Job:
RESIDENTIAL FLAT
BUILDING: - 1147, 1149
PACIFIC HWY & 2 BOBBIN
HEAD ROAD PYMBLE

BASEMENT LEVEL 1

SK04A

SOUTH ELEVATION
SCALE 1:100 @ A0

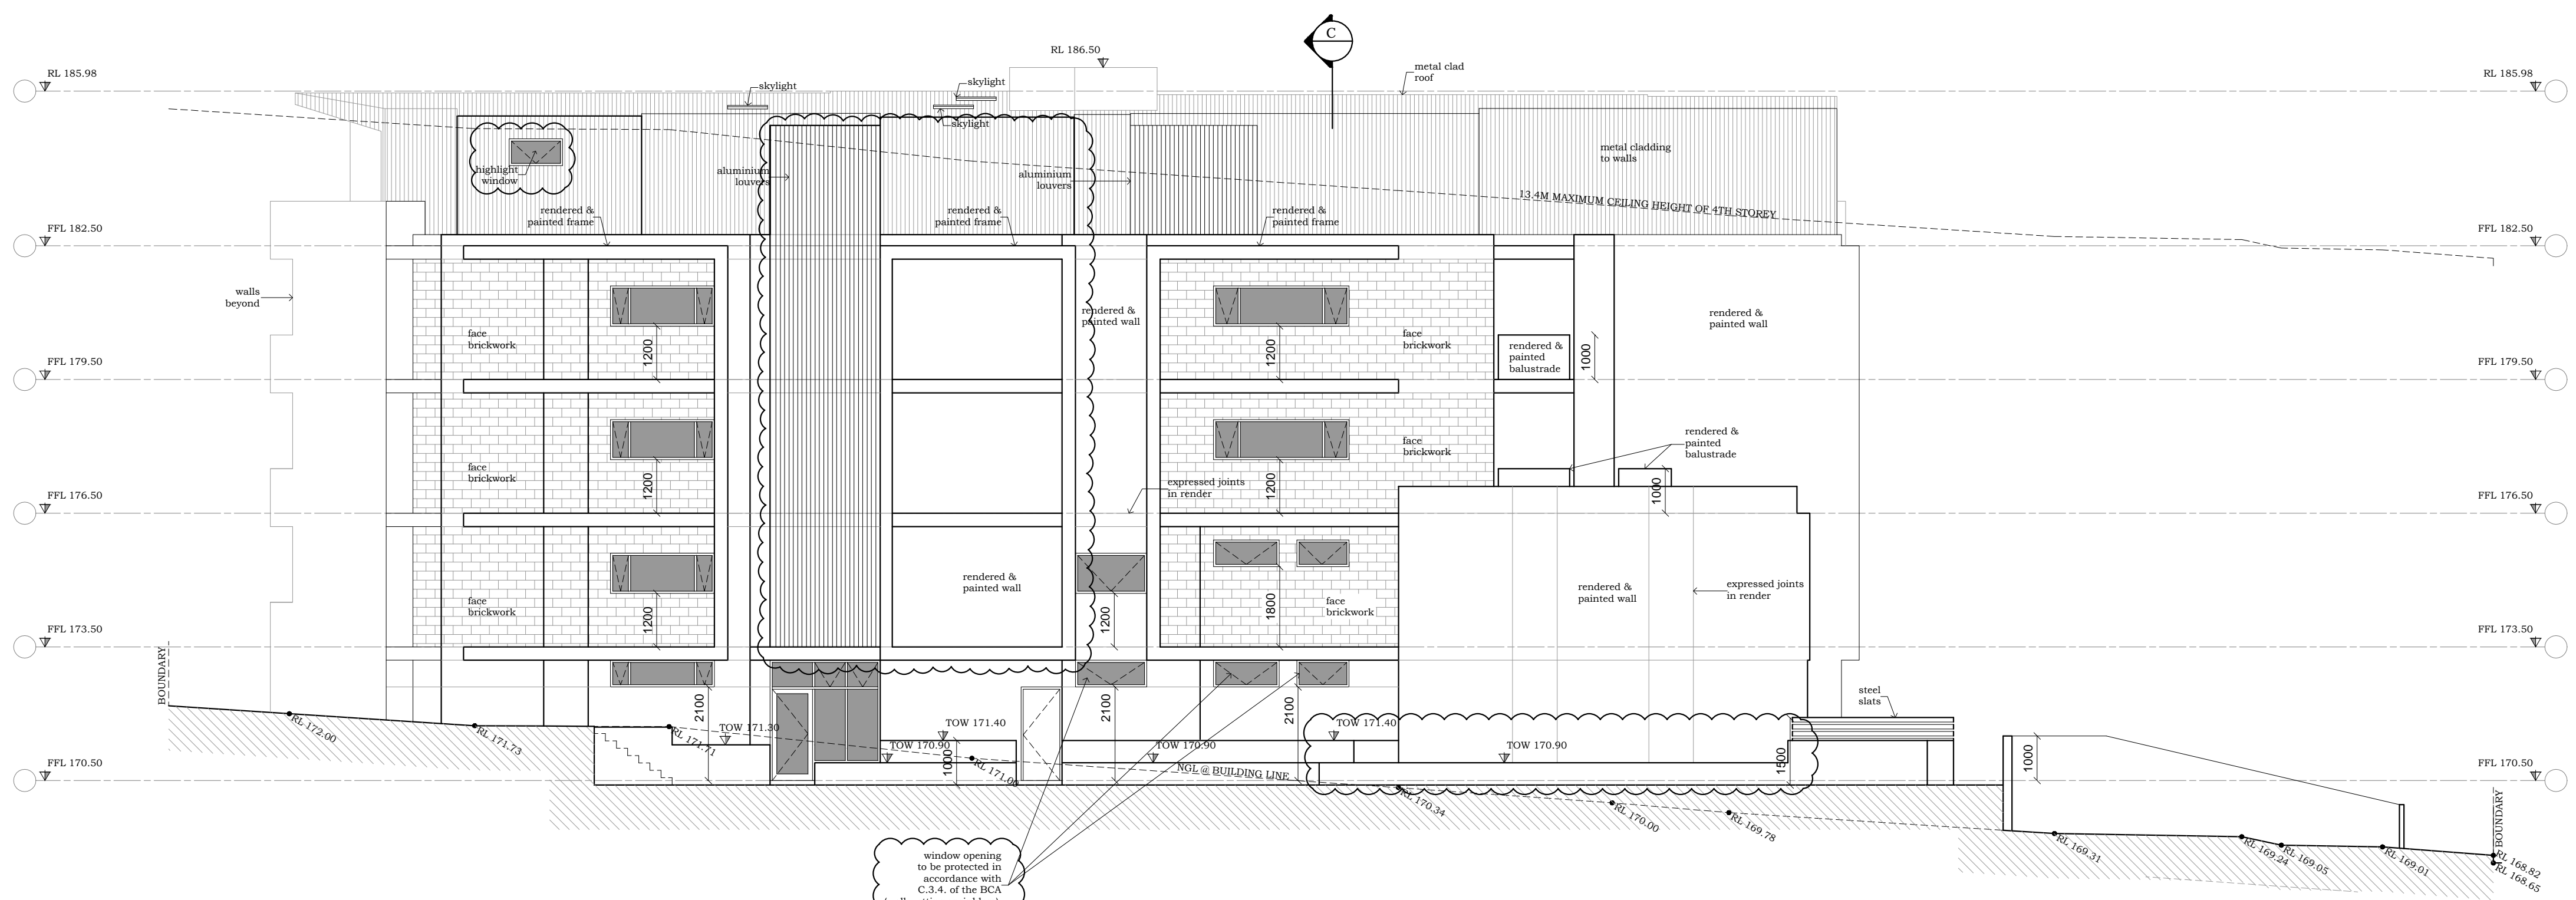
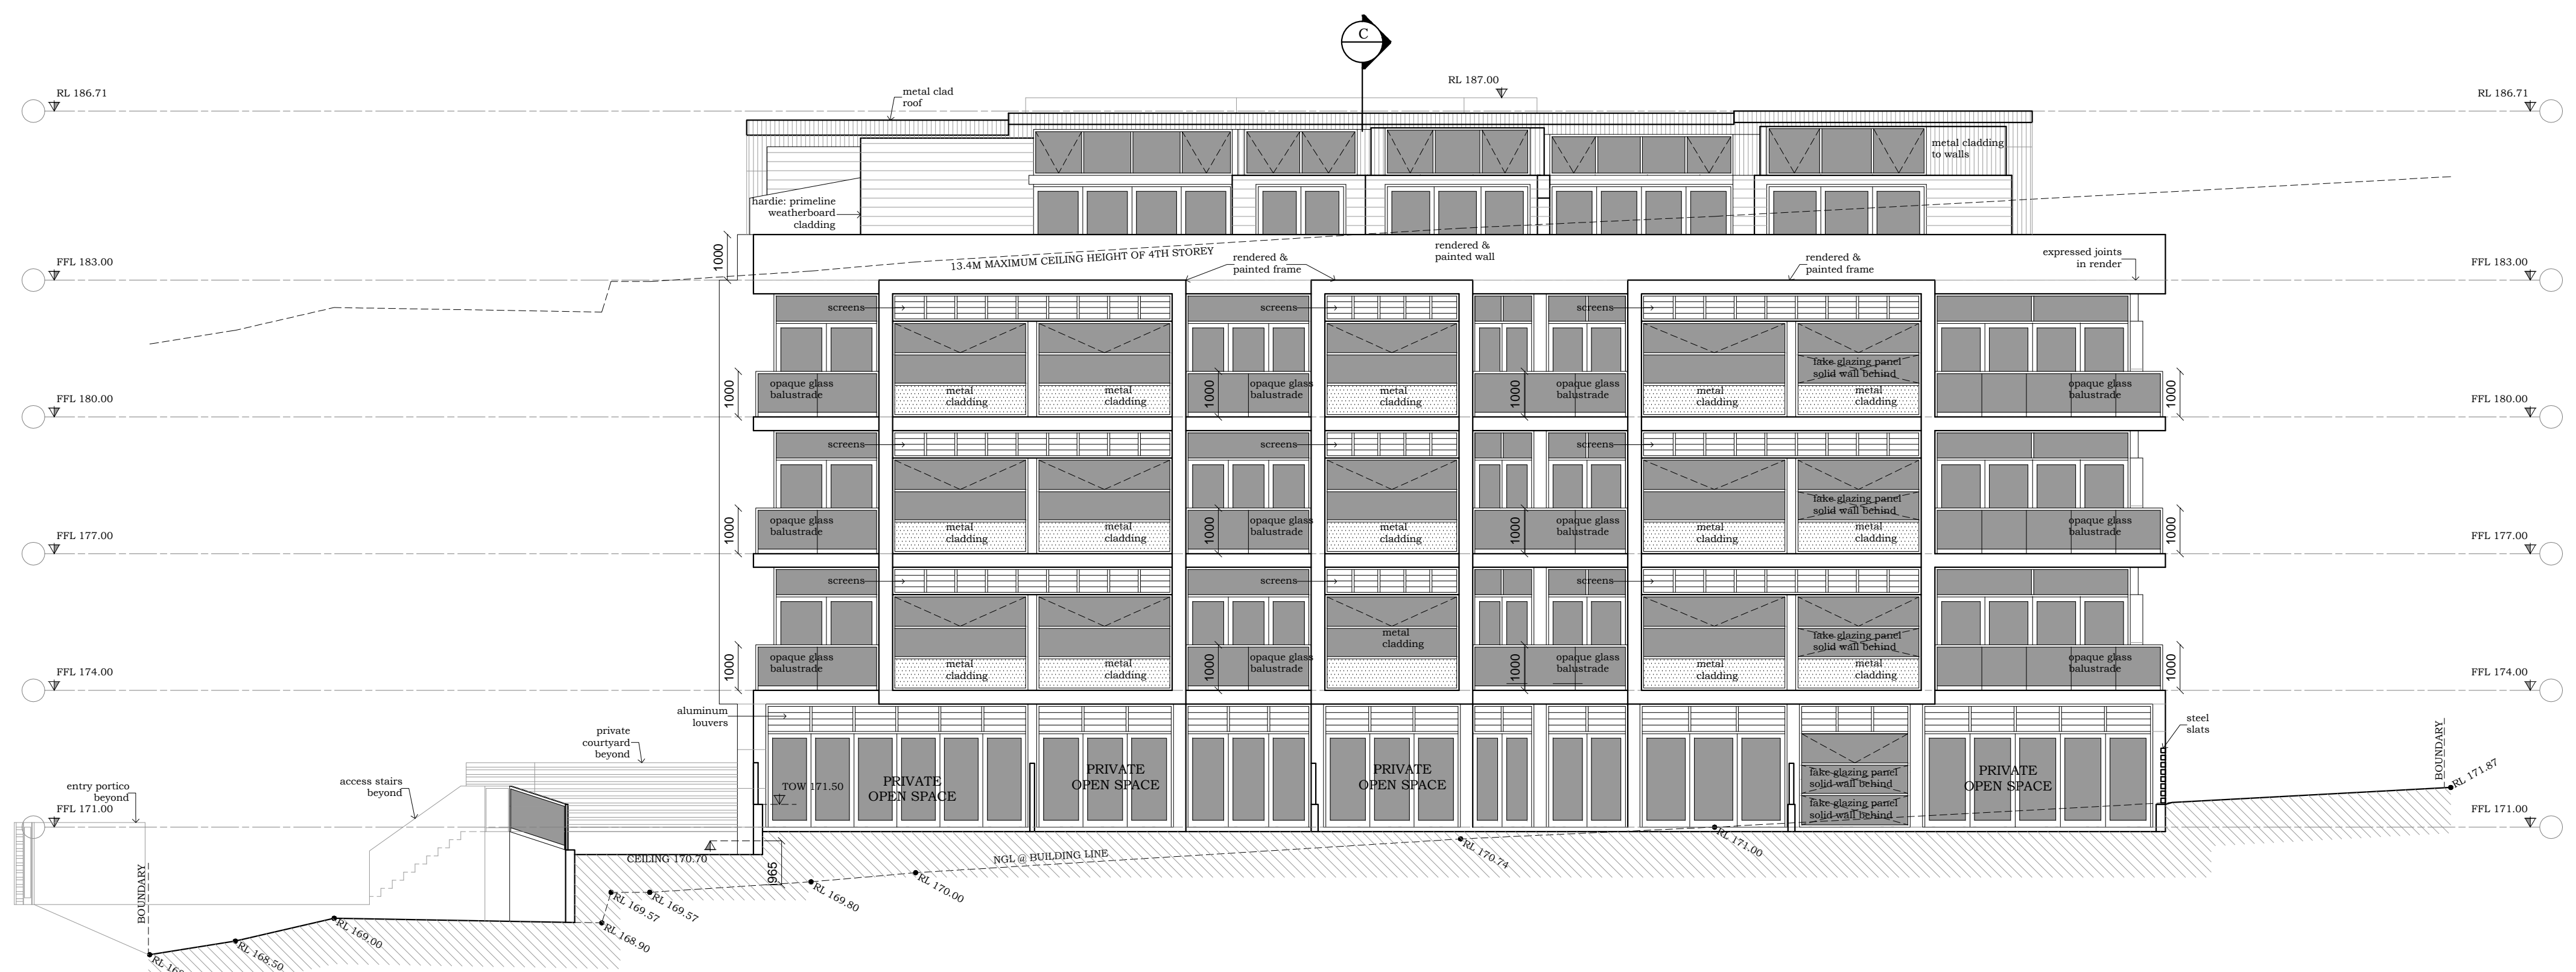
REV	AMENDMENTS	DATE
A	<ul style="list-style-type: none">- the private courtyards adjacent to the northern boundary have been setback further from the northern boundary.- egress path has been added adjacent to fire stair 3- egress path has been amended adjacent to fire stair 2 & 4 so that more doors & windows are 6m away from the egress path- Courtyard of unit 11 has increased in size.- South eastern corner of building has been modified to address corner.	30.05.11
